## UR Family

# Version 8.1x

## Release Notes

GE Publication Number: GER-4903D

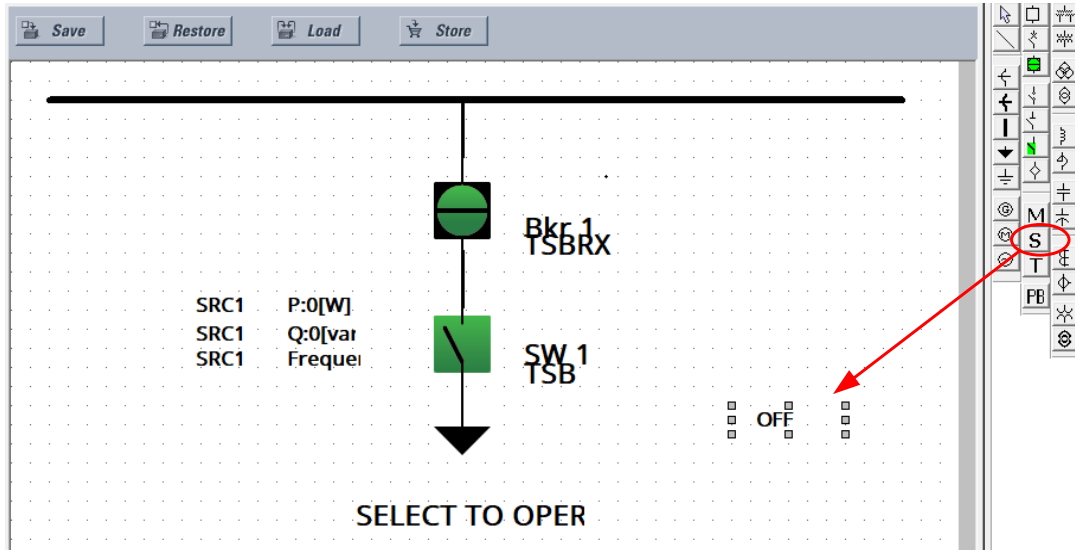
Description: Users can add Status components to graphical front panel screens by using the Single Line

Diagram Editor windows in the EnerVista UR Setup software. After synchronizing these screens to the UR, the graphical front panel shows the actual status value for each of the Status components. In previous versions, this is achieved by adding/editing Status components in the single-line diagram screen of an online device, not when adding/editing the components in offline devices that were subsequently synchronized to UR.

In the new release, this configuration is included in CID files, allowing relays to show the actual status value for each of the Status components in their graphical front panel screens.
